APPLICATION NO.	FILING DATE	FIRST NAMED INVENTOR	ATTORNEY DOCKET NO.	CONFIRMATION NO.
10/580,198	05/23/2006	Kensuke Nakamura	3209-115	1843

Office Action Summary

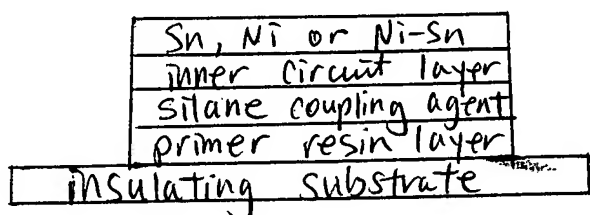
Claims 18-20 are structurally indefinite, as it is unclear the positional relationship between the primer resin layer, the inner circuit, the insulating resin layer, the surface layer, the Sn, Ni or Sn-Ni and the silane coupling agent layer? Applicant is required to clarify where each layer is located with respect to the other layer.

As for the time being, the examiner is taking these layers as following:

In claim 19, it is unclear as to which "surface layer" is referring to?
